DRAFT Planning Commission Motion NO. M-XXXXX

Hearing Date: June 15, 2017
Case No.: **2009.0159E**
Project Address: **1500-1540 Market Street (One Oak Street)**
Zoning: C-3-G - DOWNTOWN
120-R-2 and 120/400-R-2 Height and Bulk Districts
Van Ness & Market Downtown Special Use District
Block/Lot: Block 836, Lots: 001,002, 003, 004, and 005
Project Sponsor: Steve Kuklin, Build Inc.
315 Linden Street
San Francisco, CA 94102
(415)-551-7627
Staff Contact: Diane Livia – (415) 575-8758
diane.livia@sfgov.org

DATE: June 1, 2017
TO: Members of the Planning Commission and Interested Parties
FROM: Lisa Gibson, Environmental Review Officer
Re: **Attached Responses to Comments on Draft Environmental
Impact Report Case No. 2009.0159E, 1500 Market St. (One Oak)**

CITY AND COUNTY OF SAN FRANCISCO
PLANNING DEPARTMENT: CASE NO. 2009.0159E

(REVISED) FIGURE 2.3: PROPOSED GROUND FLOOR PLAN
* Note: Revised to change the label from "Loading Bike Corridor" to "Bike and Service Corridor".

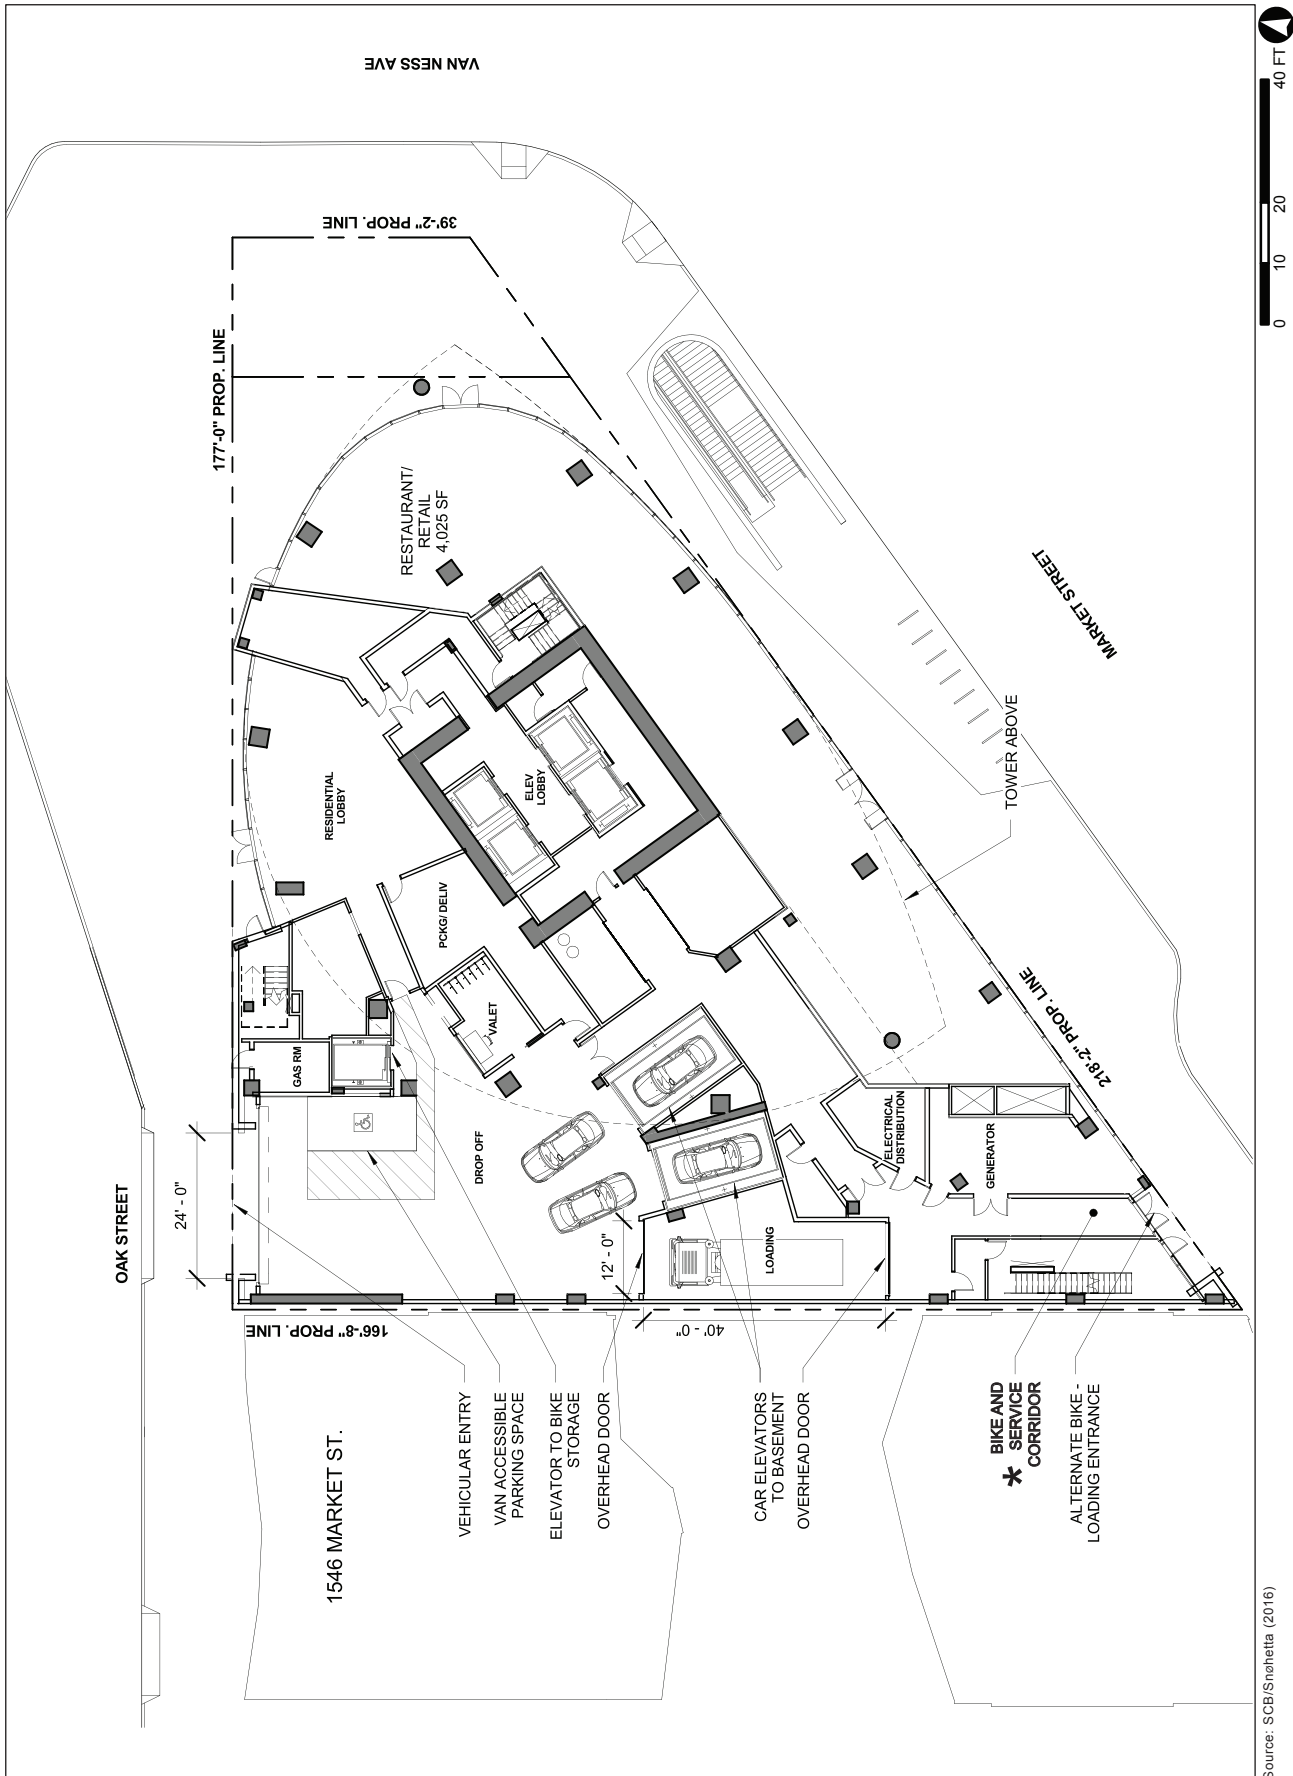
- * Figure 2.3: Proposed Ground Floor Plan, on p. 2.8, has been revised to change the label for “Loading and Bike Corridor” to “Bike and Service Corridor.” The revised figure is shown on the following page.
- * On p. 2.12, the following change has been made to the second sentence of the first complete paragraph (new text is underlined and deletions are shown in ~~striketrough~~):
- The proposed publicly accessible open space area at the ground level of the building site (~~Lots 1-5~~) and a portion of the proposed Oak Plaza within the Oak Street right-of-way ~~has~~ have been designed to satisfy the requirements for common open space for building residents under Planning Code Sections 135, 138, and 249.33.
- * On p. 2.20, the following revisions have been made to the first paragraph under “Parking Garage” (new text is underlined and deletions are shown in ~~striketrough~~):

(REVISED) FIGURE 4.E.1: LOCATION OF AFFECTED PARKS IN RELATION TO PROPOSED PROJECT

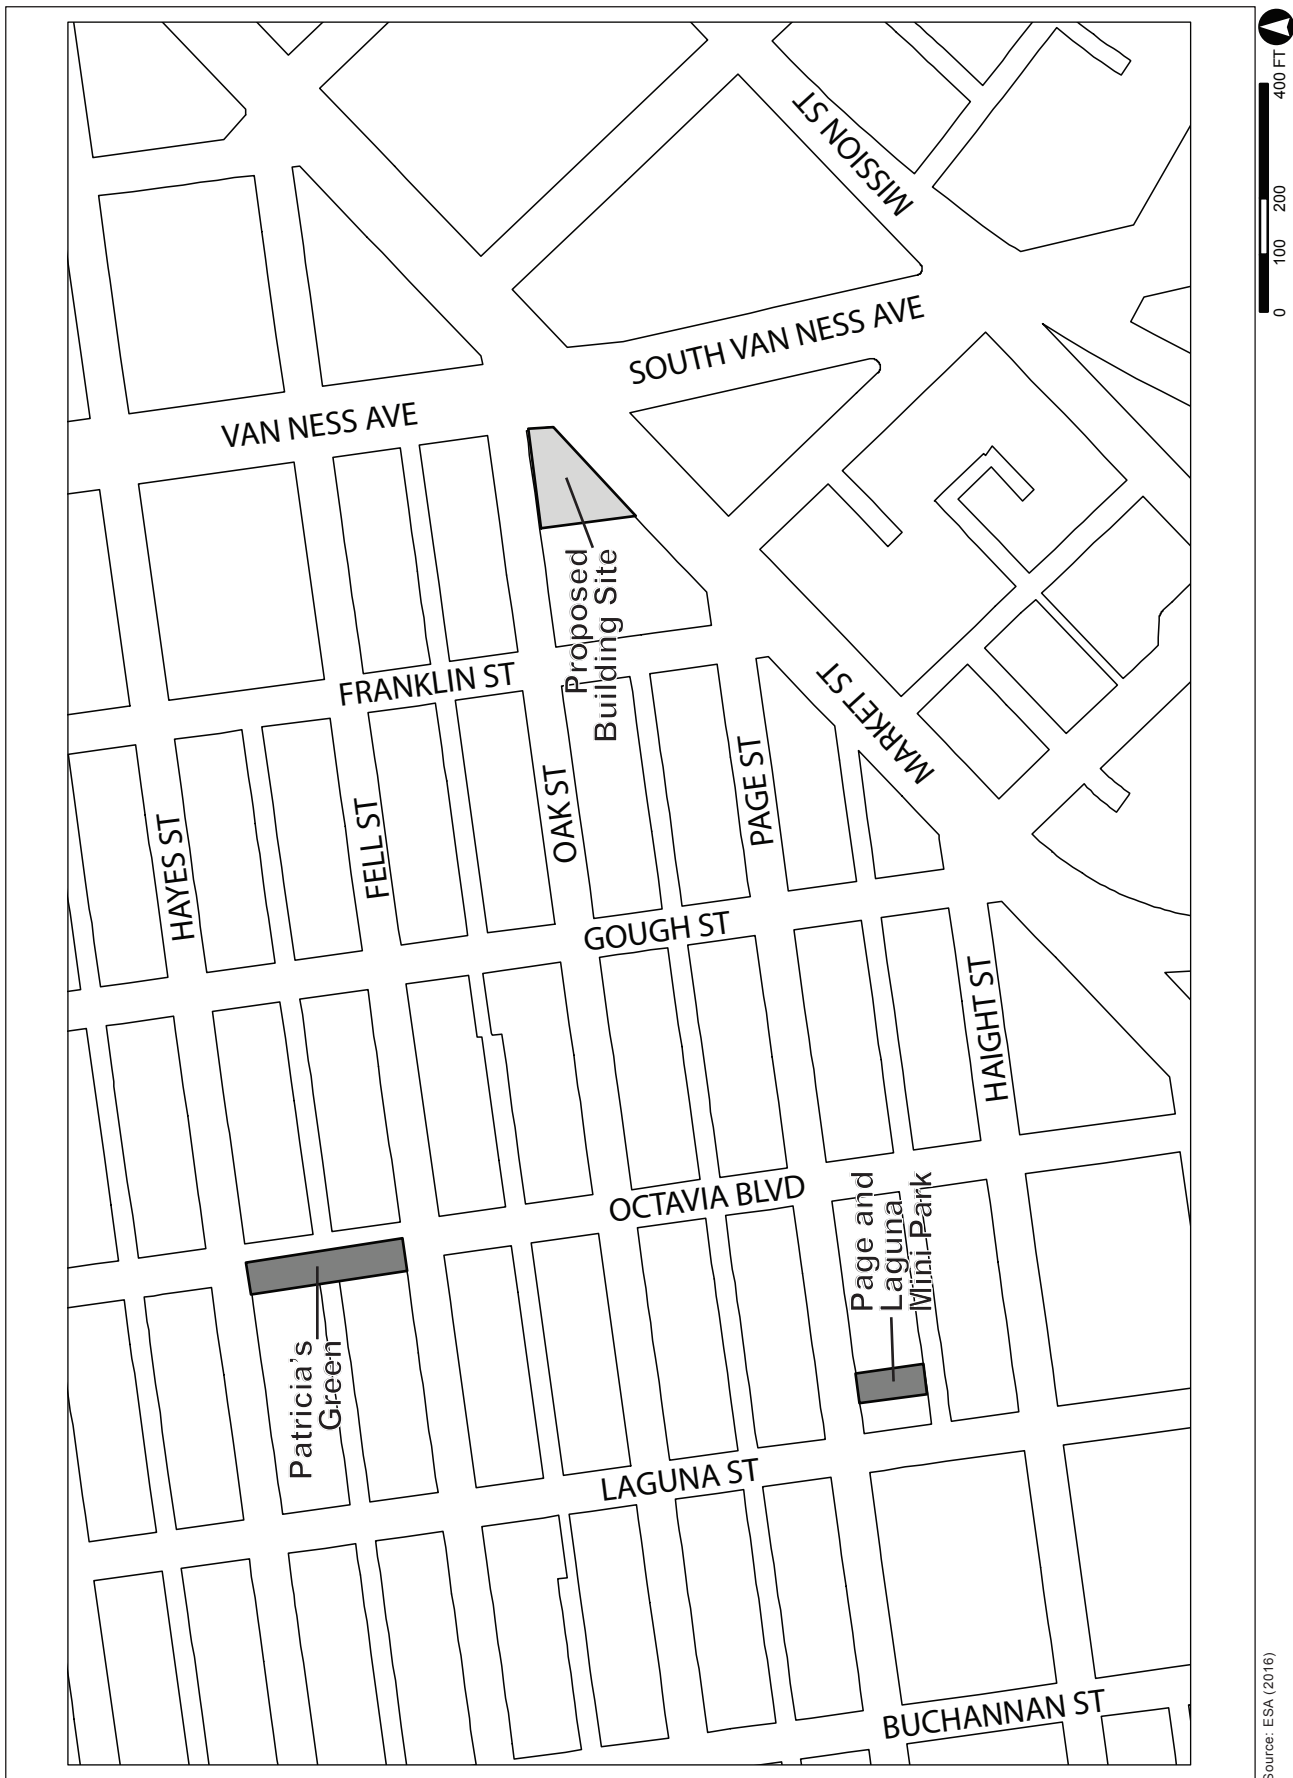
- * Figure 4.E.1: Location of Affected Parks in relation to the Proposed Project, on EIR p. 4.E.2, has been revised to remove Koshland Park. The revised figure is shown on the following page.
- * On EIR p. 4.E.5, the second and third paragraphs have been deleted to remove reference to Koshland Park, and the fourth paragraph has been revised to introduce (Revised) Figure 4.E.2: Page and Laguna Mini Park, as follows (new text is underlined and deletions are shown in ~~strikethrough~~):

(REVISED) FIGURE 4.E.3 MAXIMUM NEW PROJECT SHADOW ON PATRICIA'S GREEN 8:30 AM ON OCTOBER 4 / MARCH 8

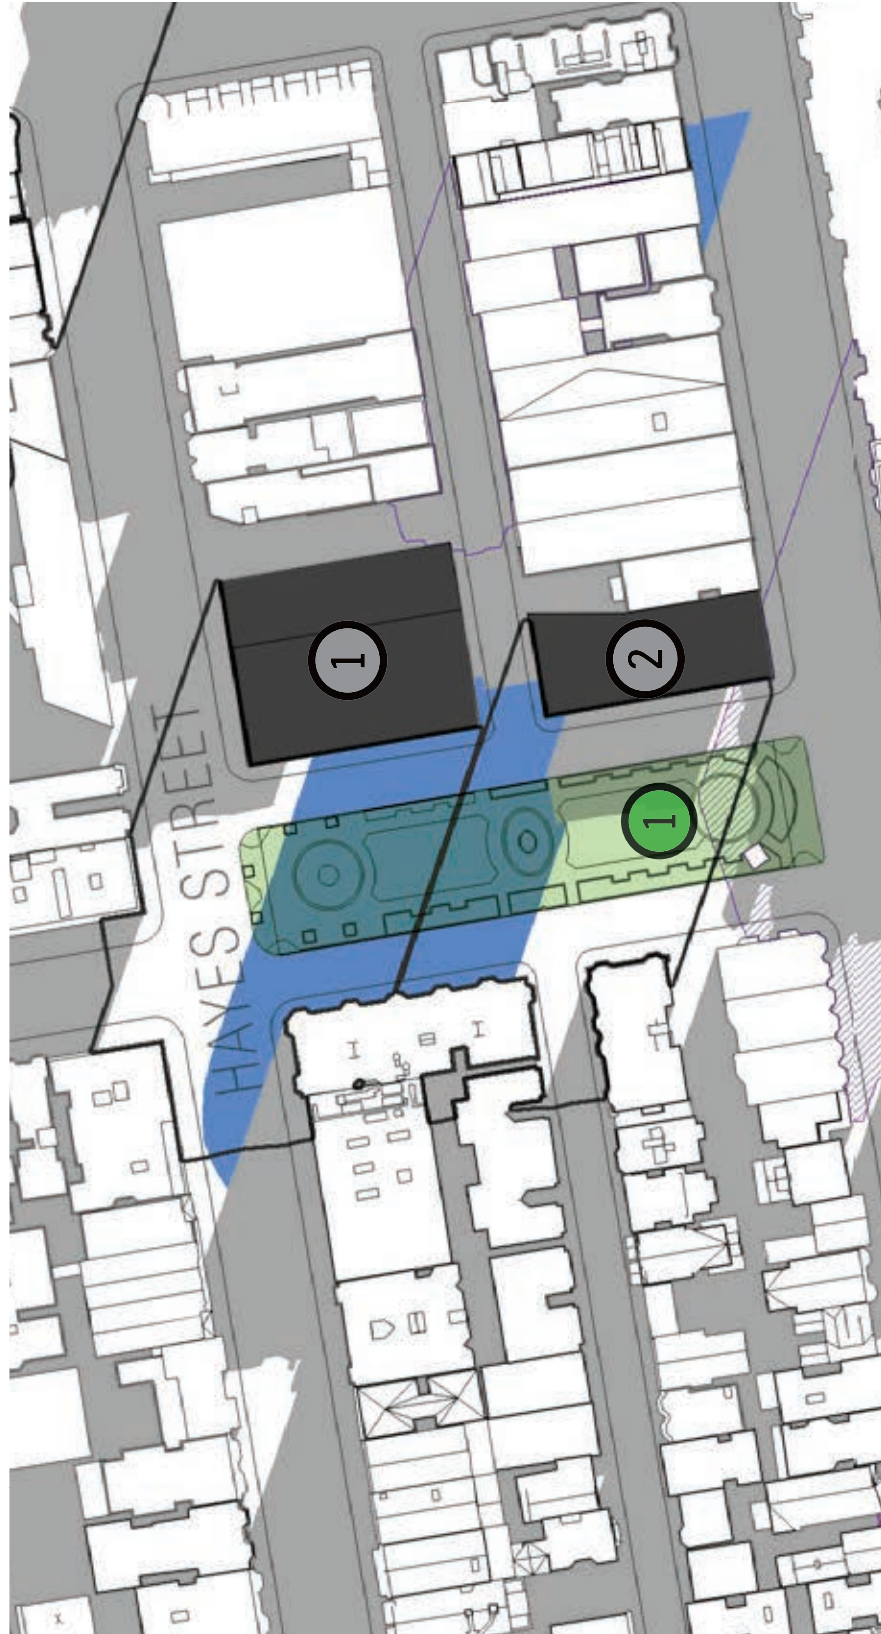
- * DEIR Figure 4.E.3: Maximum Extent of New Project Shadow on Patricia's Green, 8:30 AM on October 11/March 2, on EIR p. 4.E.15, has been revised to use the updated shadow projection diagram provided by PreVision, as shown on the following page.
